Appeal Period Expires 6/16/22 Zoning District R.P.D.F. **Town of Essex, Vermont** Application for Zoning Permit (Building Permit) Application Date 1/1/22 Permit Number 2022-71

TOWN OF ESSEX, VERMONT APPLICATION FOR CURB CUT / UTILITY PERMIT

DRIVEWAY (TYPE A)

21A + 23 Corporate Dr

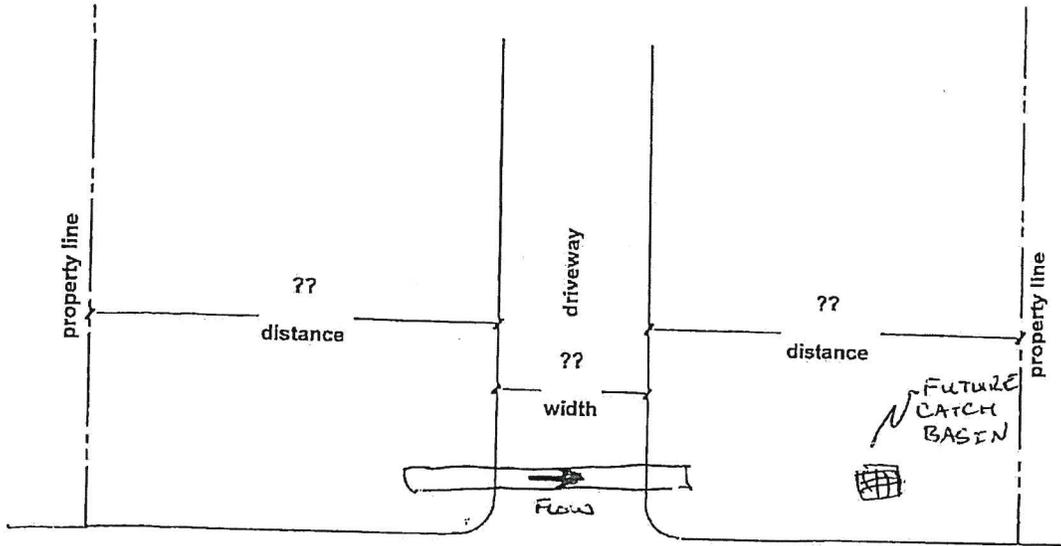
1. Culvert must be HIGH DENSITY POLYETHYLENE (HDPE) PIPE
2. Culvert will be purchased by the Applicant
3. Culvert will be purchased and installed by the applicant. The Town of Essex Department of Public Works will inspect.

- DRIVE WIDTH & APRON PLAN VIEW LAYOUT AS PER APPROVED SITE PLAN.
- SUBBASE MATERIAL & THICKNESS AS PER DETAIL A-10 ATTACHED, SAME APPLIES TO PAVEMENT & CURBS.
- INSTALL CULVERT TO FLOW TOWARDS FUTURE CATCH BASIN.
